Access Compliance Report Public Rights-of-Way (Curb Ramps)

Cross Street: PARK RD SHOPPING CENTER DR Intersection ID: 30402 Main Street: WOODLAWN RD SW Location: **Severity Score:** 22.5 ADA ID: D885306330DA Ramp Type: PerpDiag Initial Pass/Fail: Fail **Overall Compliance: No**

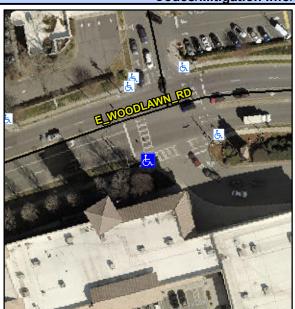
Remove & Replace Curb Ramp With Two New Directional Ramps or Equivalent. Surveyor Notes: N/A PROW/ADA: Not Found, R304.5.1, R304.2.2,

R304.5.3

Possible Solutions:
